Date: 24th October 2014

Subject: Proposed RPC CPZ (Cambridge Road Area, Raynes Park – Statutory consultation

Appendix 1 – Amended proposals drawing no. Z78-212-01 Rev C

Appendix 2 – Amended proposals drawing no. Z78-212-01 Rev D

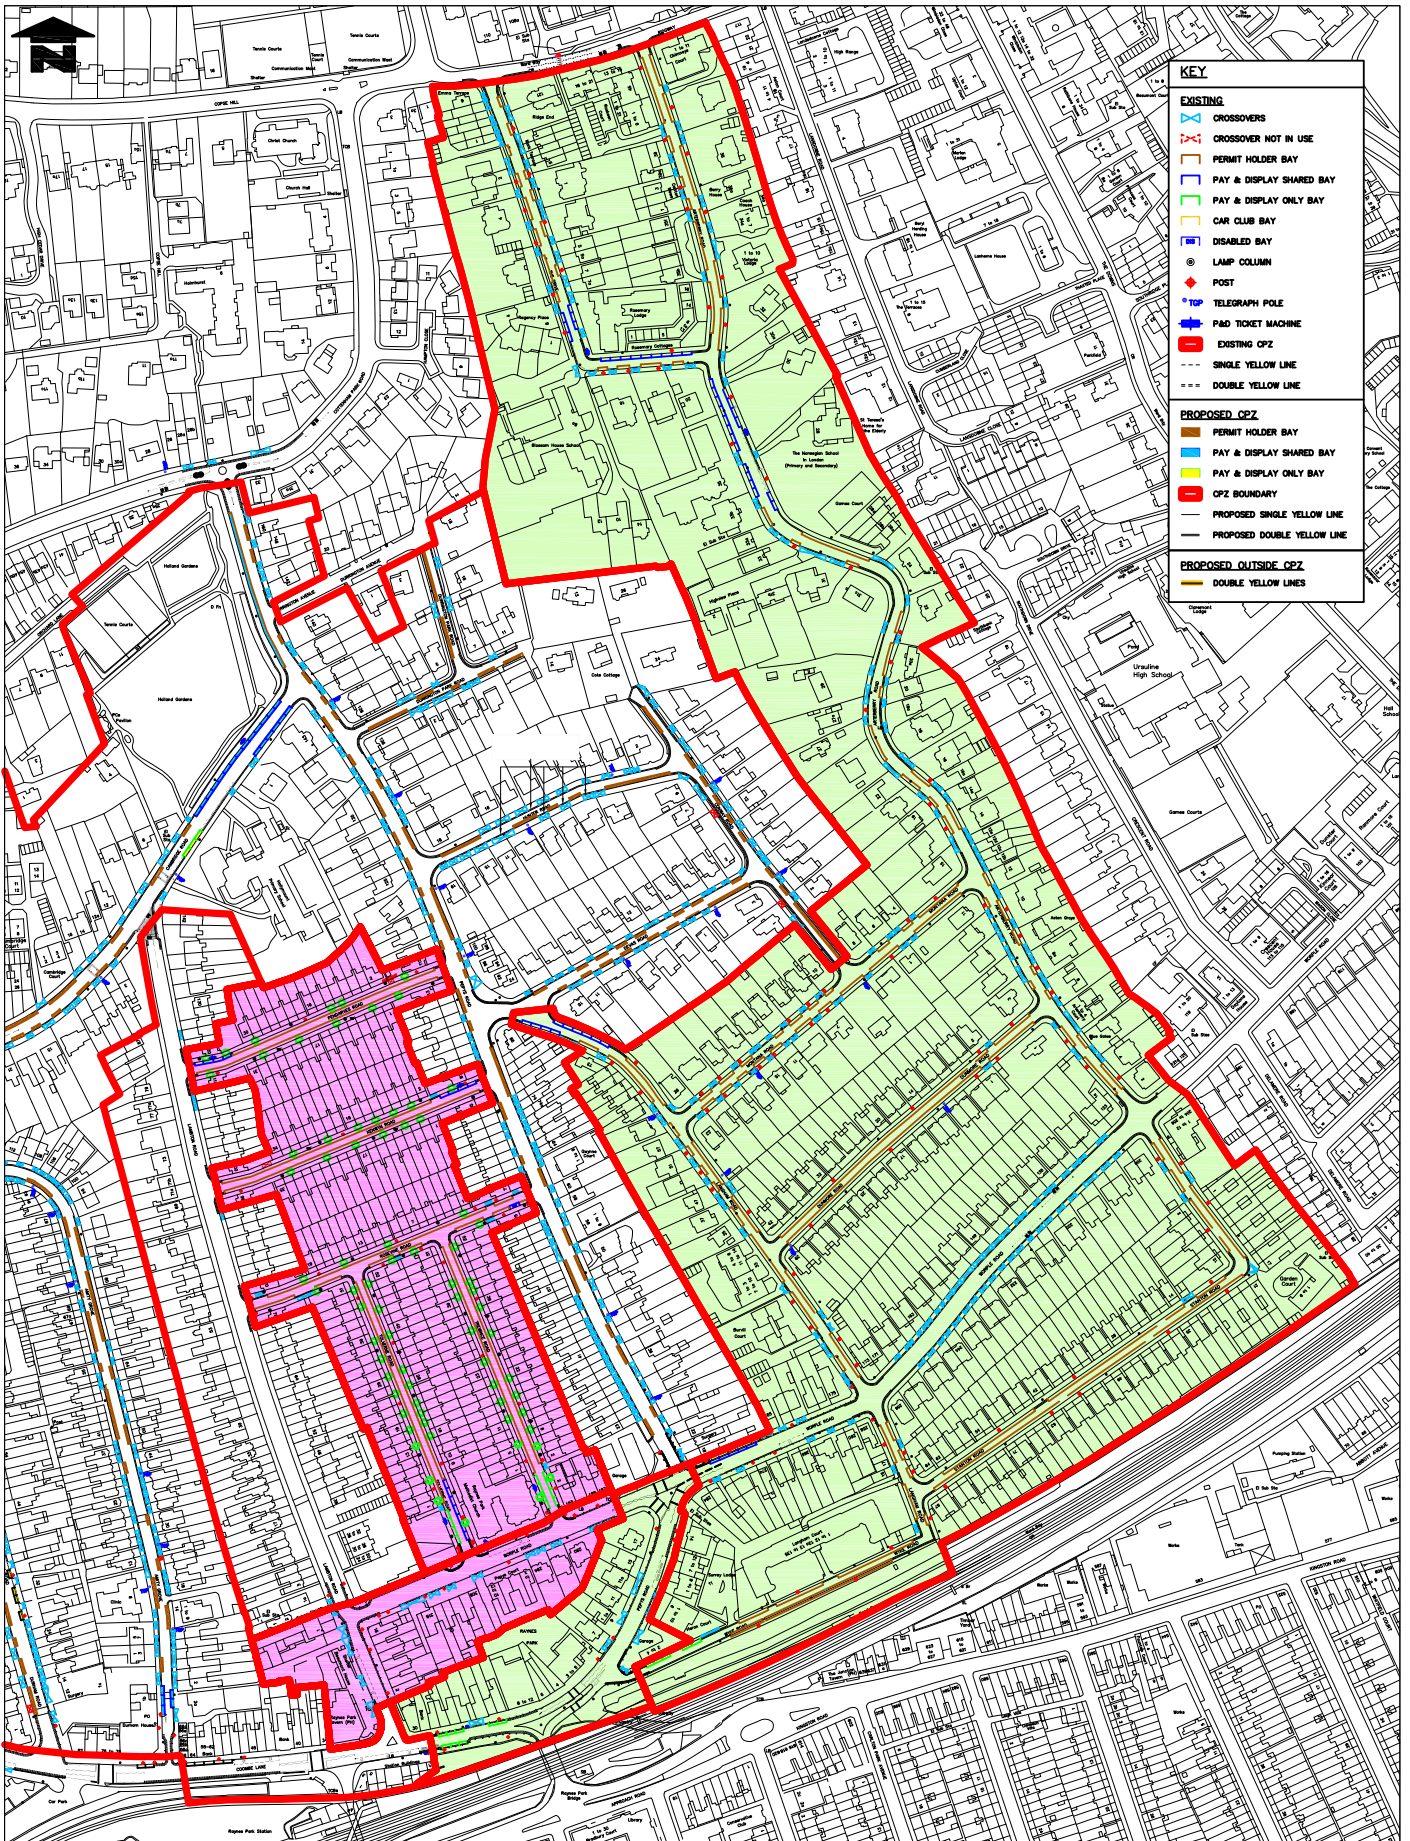
- G) Agrees to proceed with a statutory consultation to include Melbury Gardens and Laurel Road into the RPC CPZ, operational Monday to Friday between 11am and 12pm as

- 1.9 It seeks approval to proceed with a statutory consultation to introduce single yellow line in Coombe Lane between 184 and its junction with Cambridge Road into the RPC CPZ, operational Monday to Friday between 8.30am and 6.30pm as shown in Drawing No. Z78-212-01 Rev D in Appendix 2.

- 1.7 It seeks approval to proceed with a statutory consultation to include Melbury Gardens and Laurel Road into the RPC CPZ, operational Monday to Friday between 11am and 12pm as shown in Drawing No. Z78-212-01 Rev D in Appendix 2.
